**ADDENDUM NO. 4**

Date: September 14, 2018  
Project: **Secondary Treatment Plant Upgrade & Recycled Water Expansion**  
Job No.: 12600-07/16650-02

**PRIMARY PUMP STATION  
BLOWER/WAS PUMP AREA PLAN**

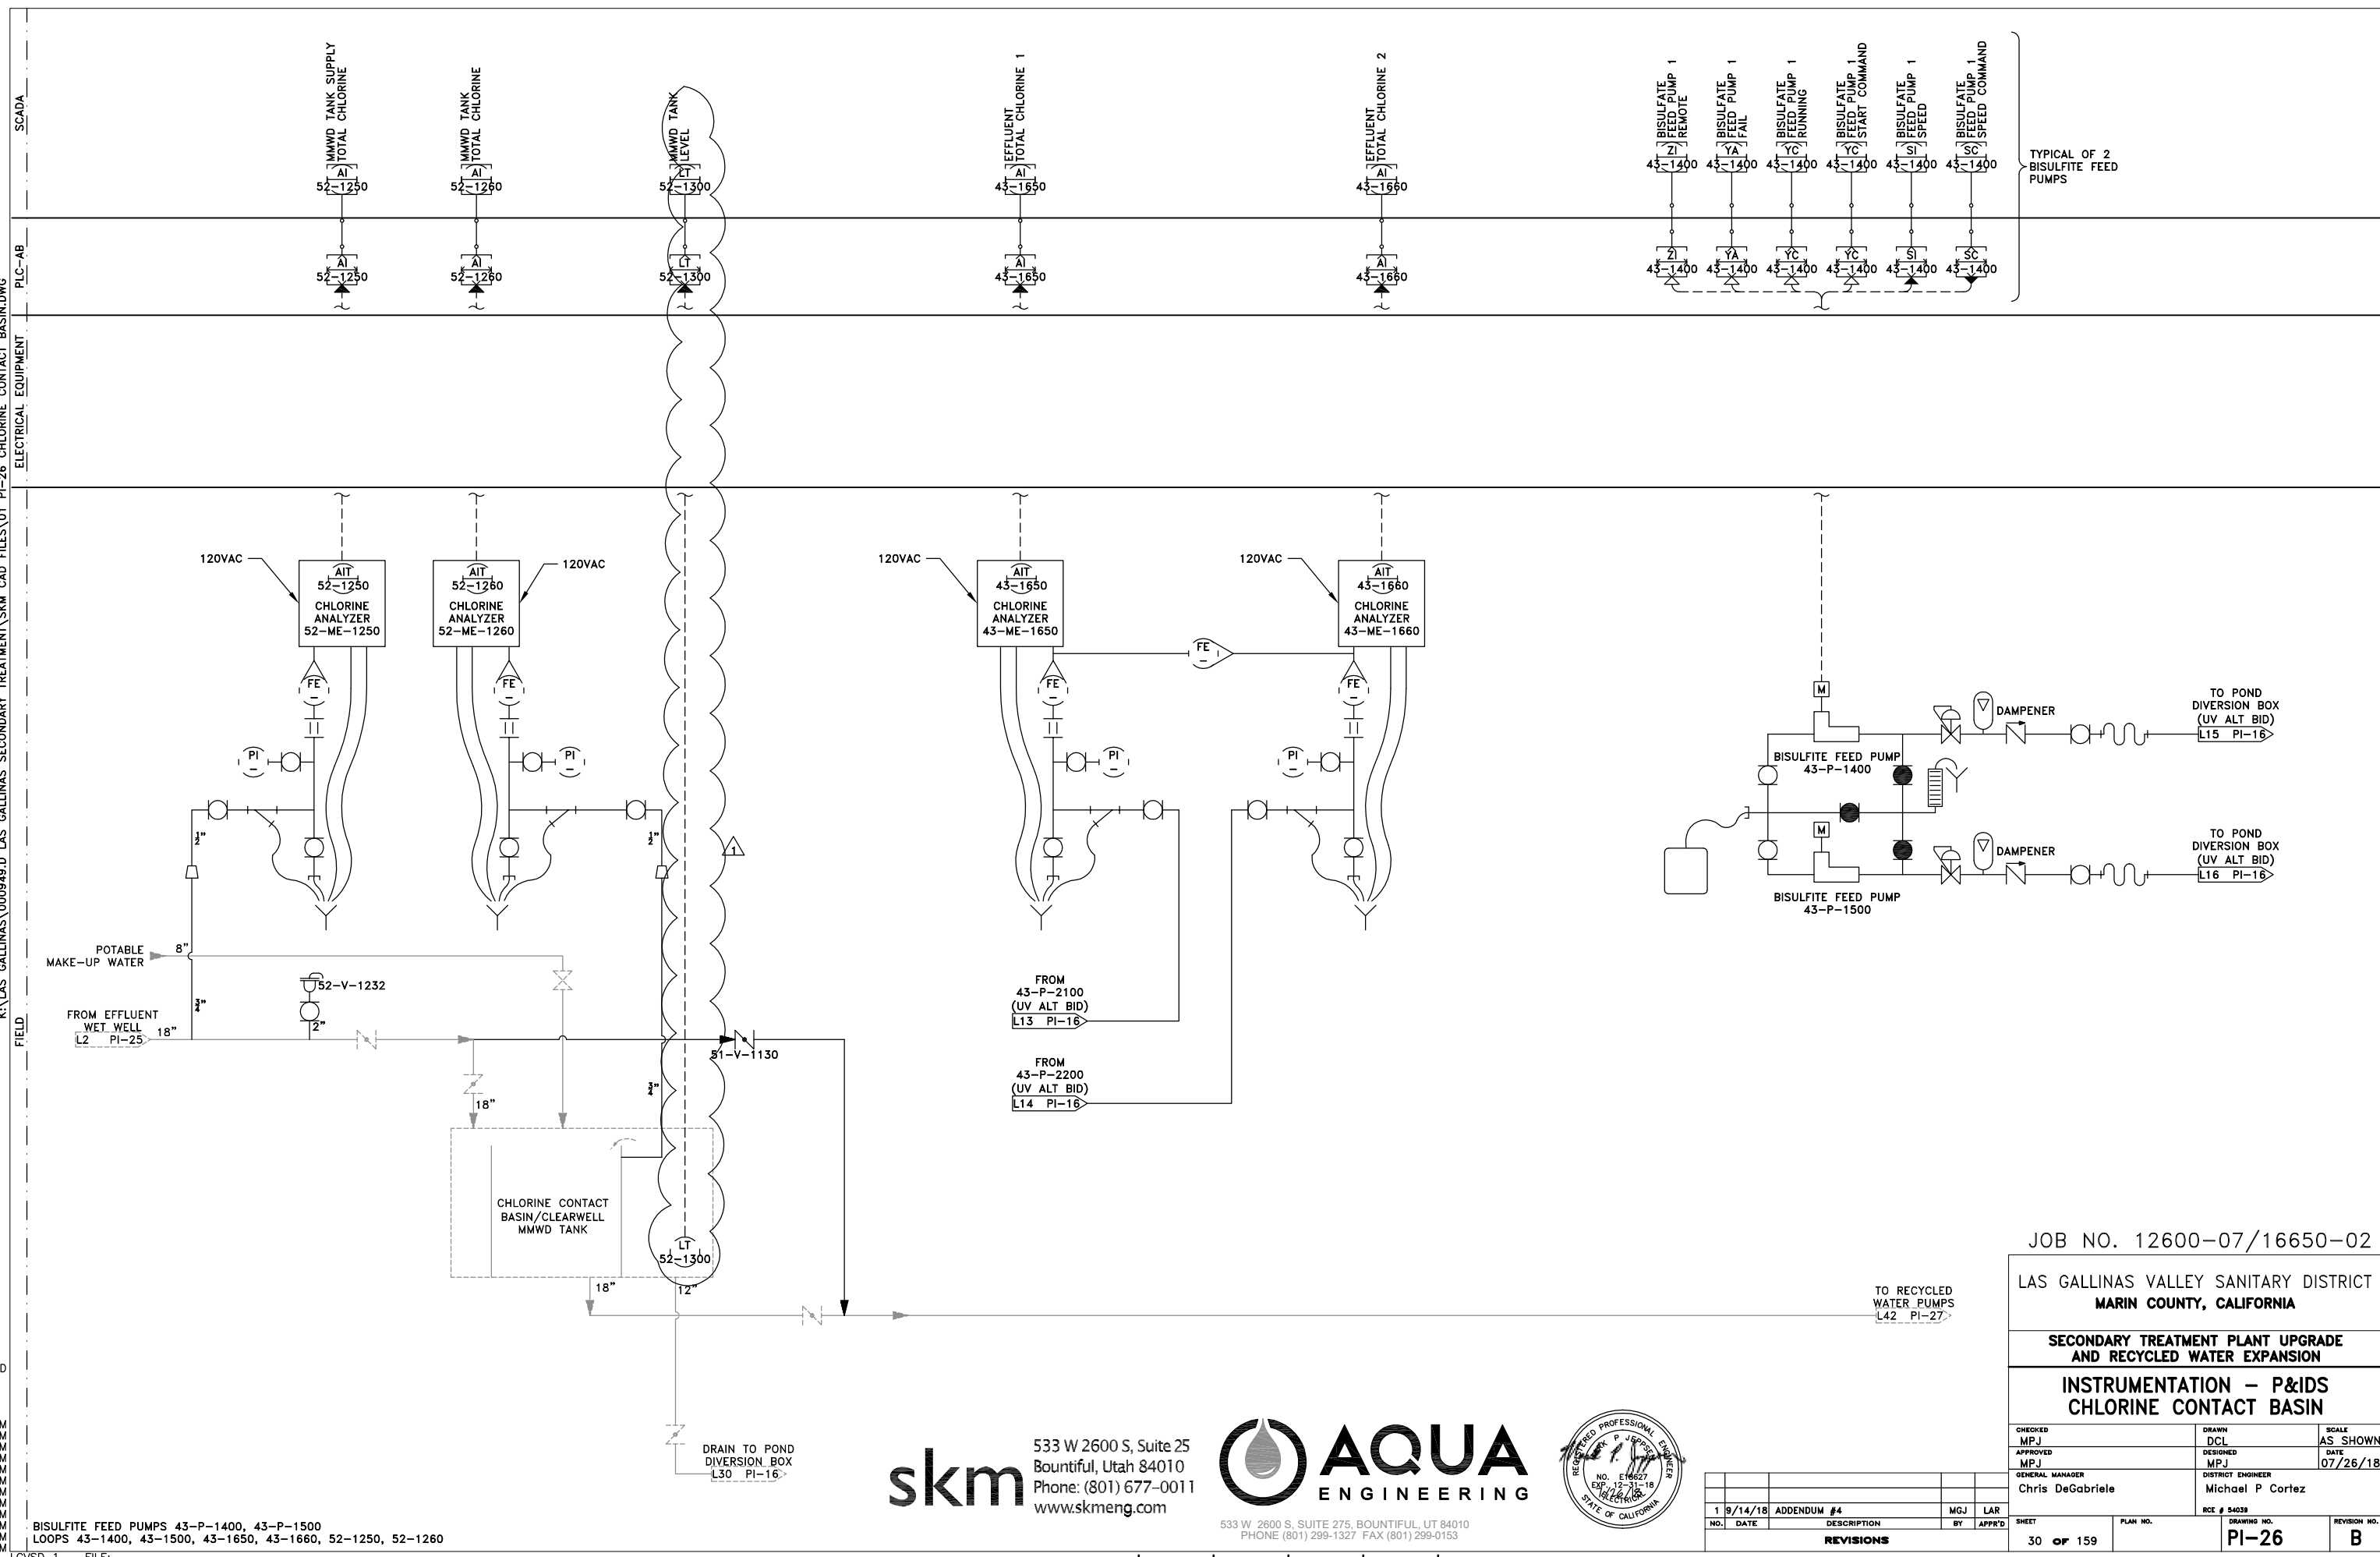
9. **Sheets PSM-1, PSM-3, and PSM-5:** The 4-inch secondary clarifier scum line has been rerouted to feed into the drain box (the deepest basin adjacent to the RAS collection boxes) that houses pump 61-P-1300. The discharge for this pump has been modified to include a second discharge option, including two new valves (check and isolation plug valves **61-V-1311** and **61-V-1312** respectively) and an additional 4" DIP/HDPE discharge line that connects to the WAS pump discharge line below grade. These sheets have been modified to show the new route of the 4" scum line and the new discharge line/valves associated with the drain pump. Note that other drawings in the PSM area will be updated to reconcile with this change for the construction set. **Revised versions of these sheets are provided as an attachment to this addendum for reference.**

CHECKED MPJ	DRAWN DCL	SCALE AS SHOWN
APPROVED MPJ	DESIGNED MPJ	DATE 07/26/18
GENERAL MANAGER Chris DeGabriele		DISTRICT ENGINEER Michael P Cortez
SHEET 86 of 159		REVISION NO. SE-02
PLAN NO.		REVISION NO. B

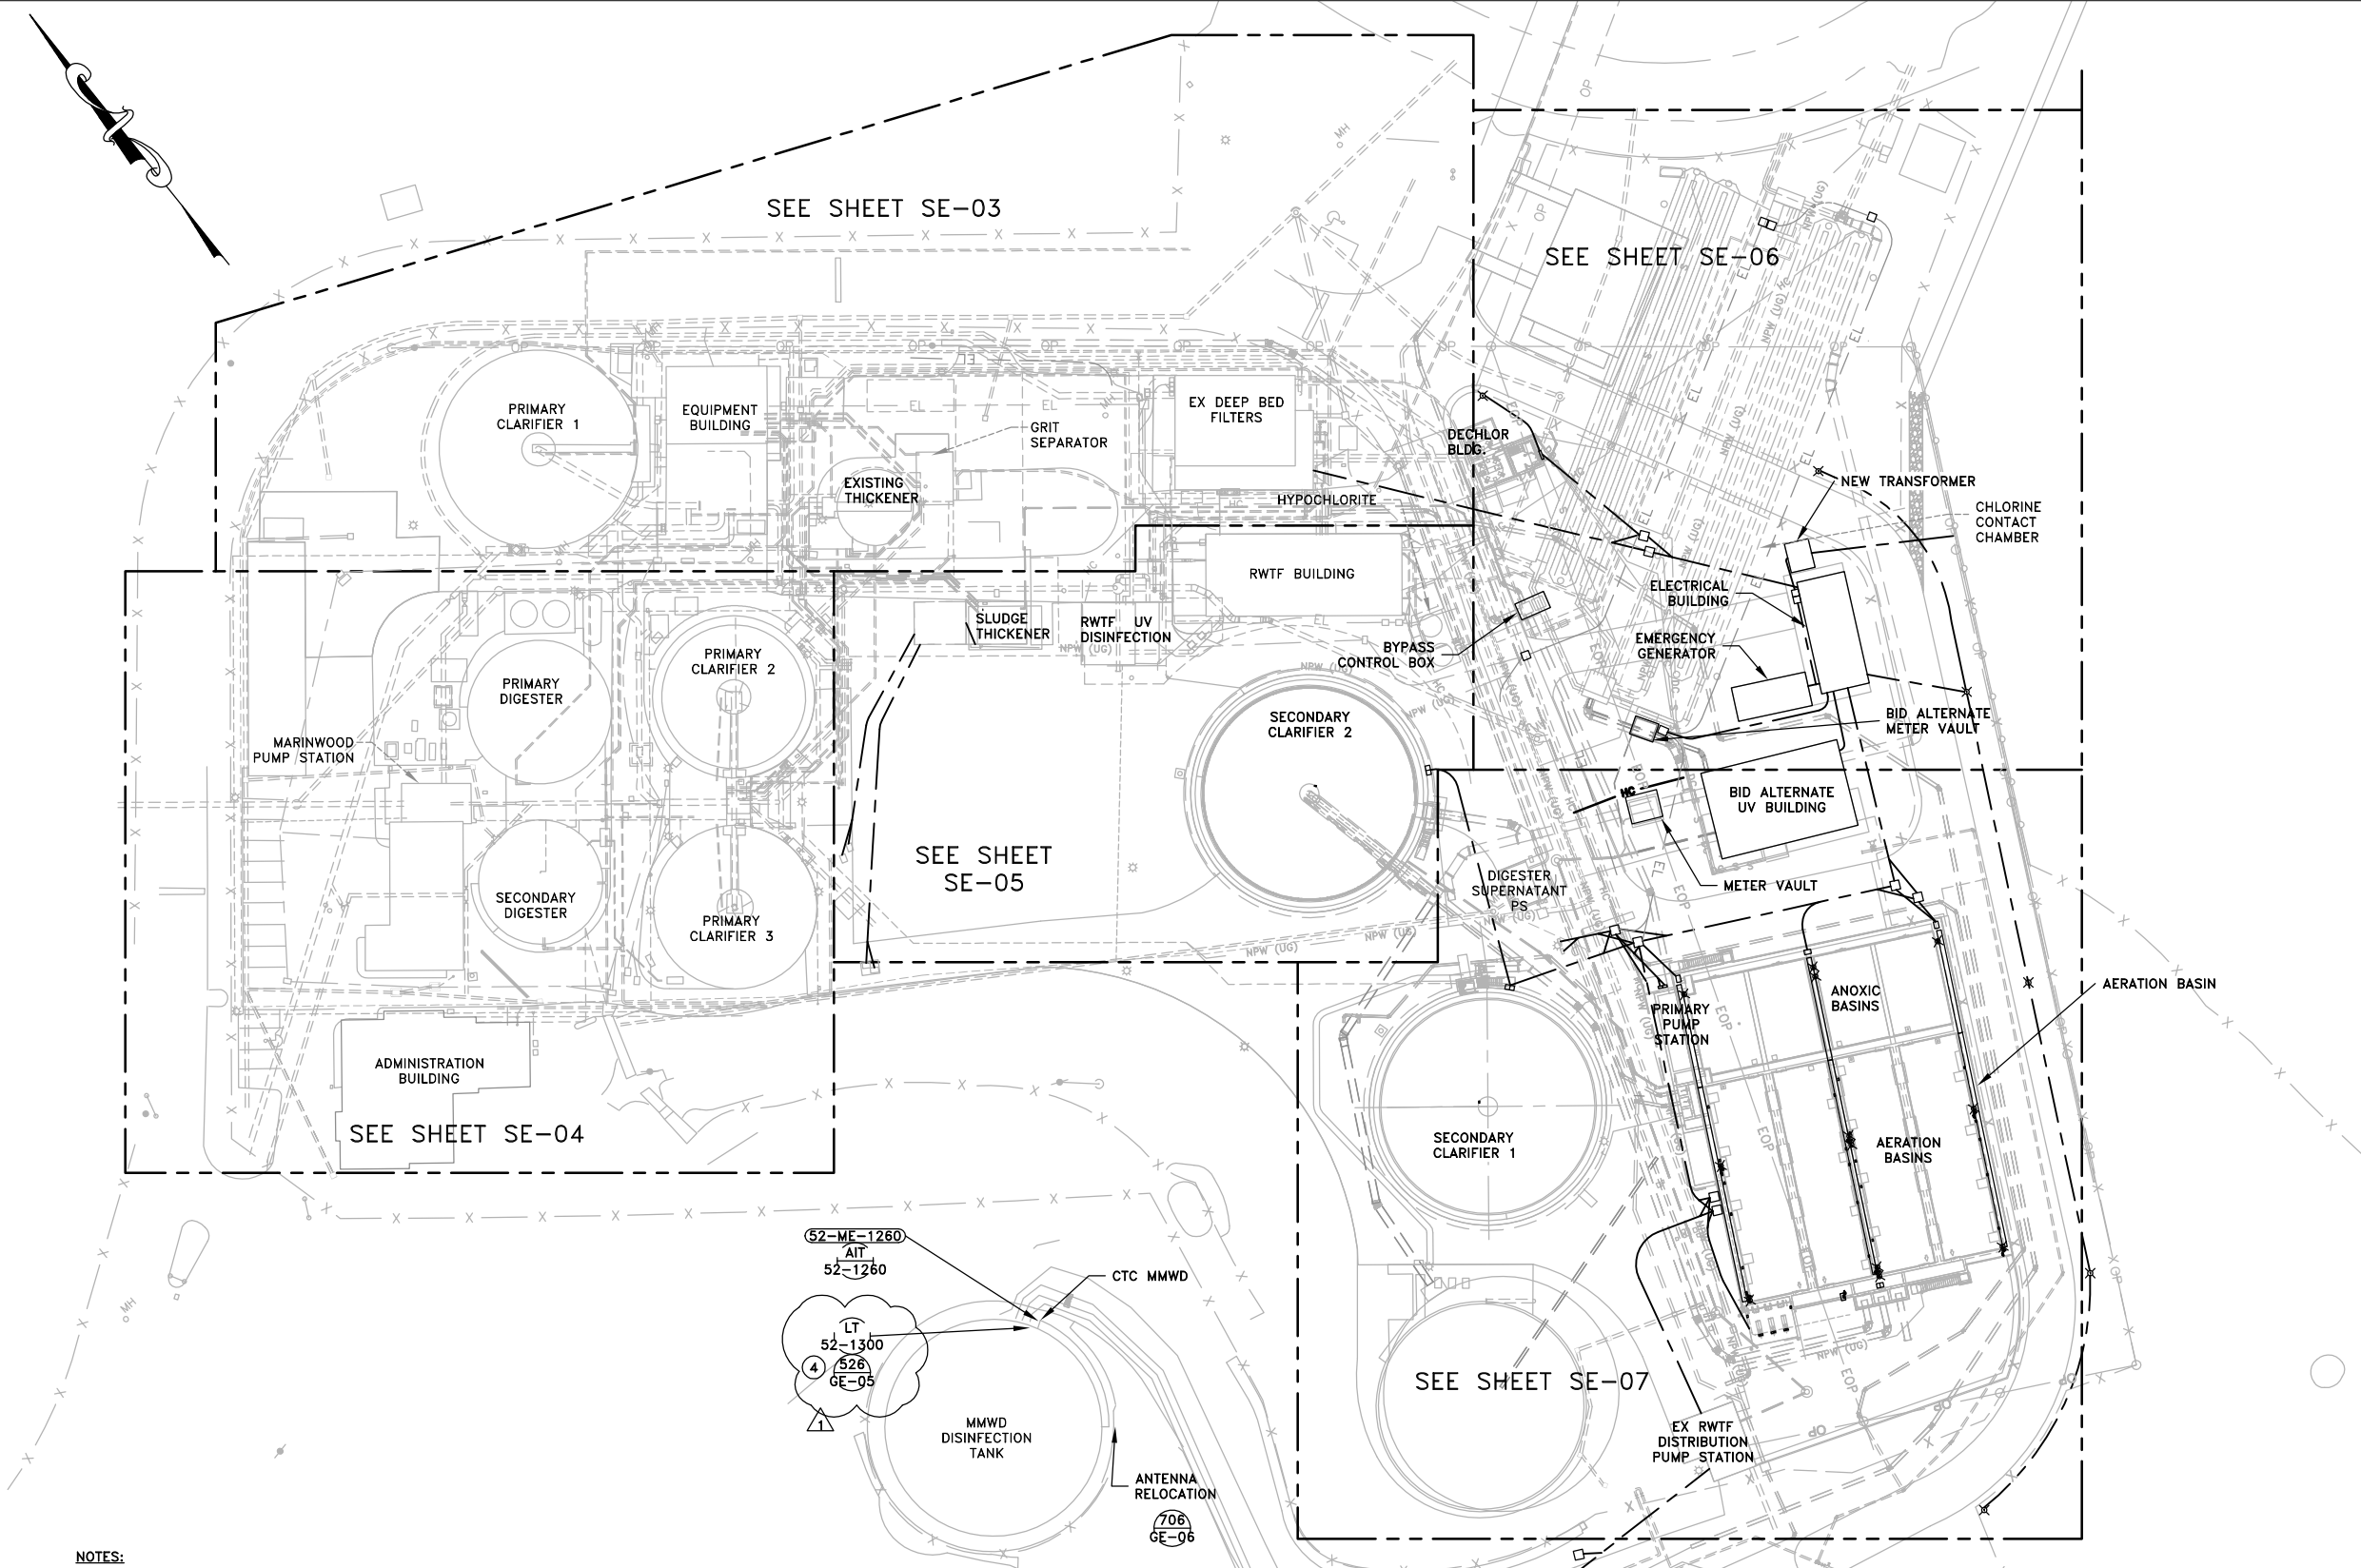
4. **Sheet SE-02, SE-06, SE-07:** Sheets have been re-issued to show street lighting and associated ductbanks.
5. **Sheet E-4:** Remove the manual transfer switch and associated Note 4.

SHEET 94 OF 159	PLAN NO.	DRAWING NO. <b>LE-02</b>	REVISION NO. <b>B</b>
--------------------	----------	-----------------------------	--------------------------

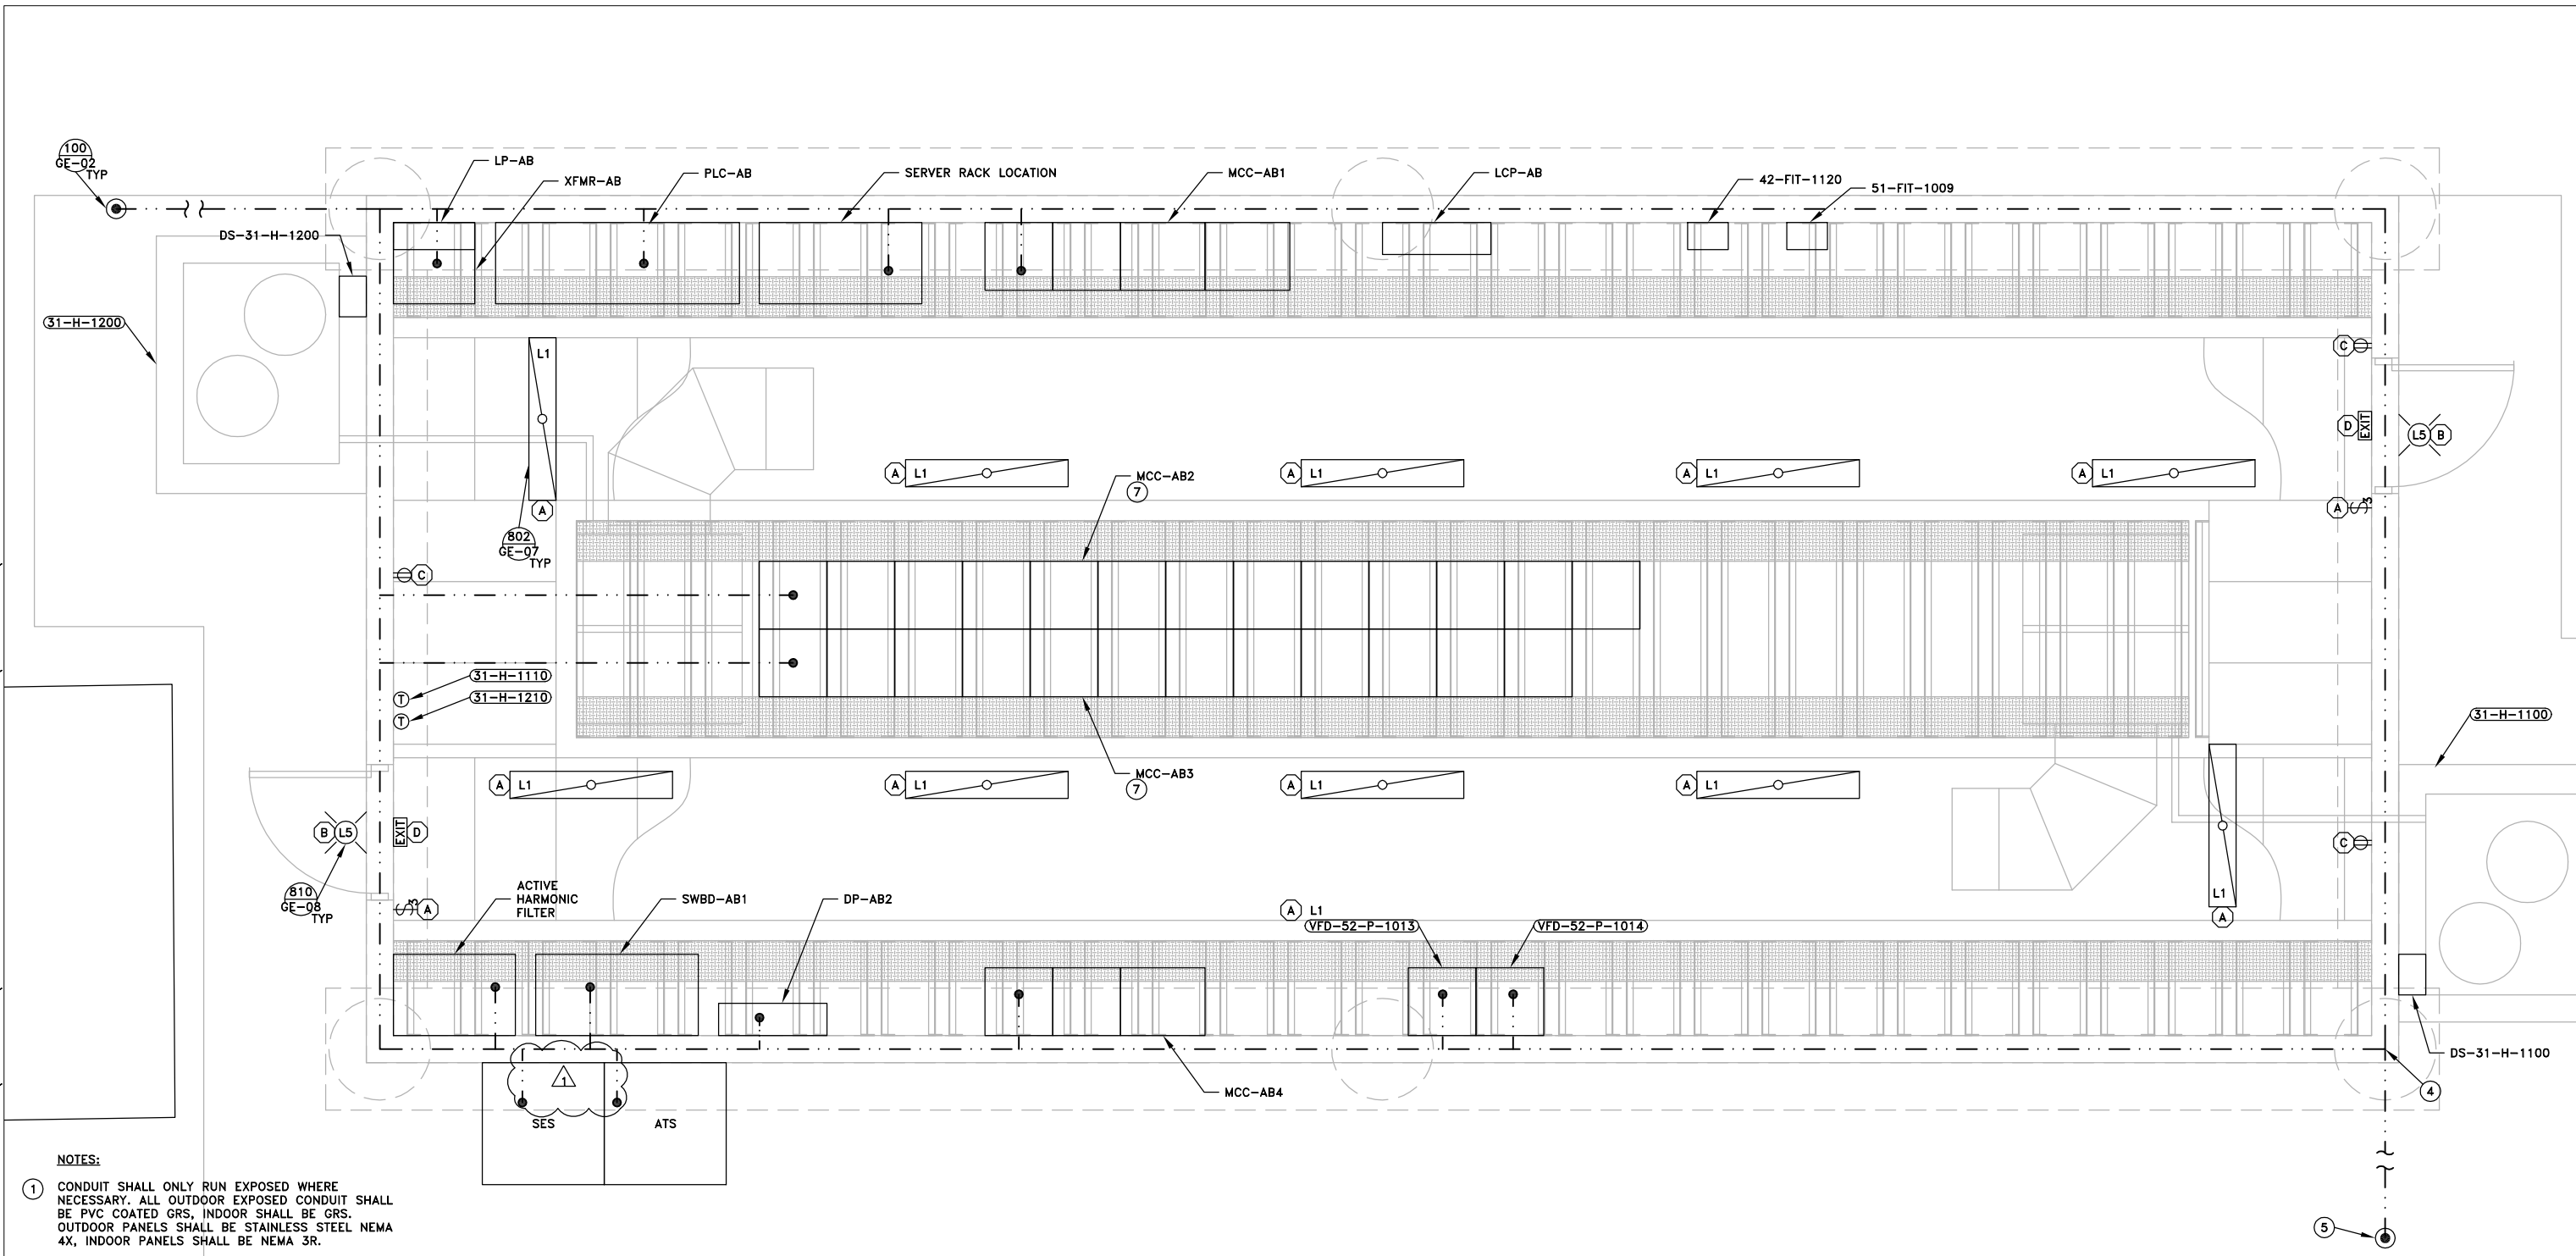
1. **Sheet PI-26:** Sheet has been re-issued to show level transducer on MMWD tank
2. **Sheet LE-02, SE-06:** The SES as shown occupies one section. It is anticipated that the SES will occupy two sections, so twice the size as shown on the drawings. Shift the ATS south along the wall to provide space for the SES.

3. **Sheet LE-02, LE-03, LE-04, LE-10 and LE-14:** Have been re-issued to show more detail on grounding. Grounding of structure and major process equipment is shown. Contractor is still responsible for grounding metal surfaces such as hand rails and roofs to the UFER ground.

6. Drawing LE-02 - There is a callout in the upper right hand corner of this drawing for Detail 1010 / GE-09. This detail does not exist.
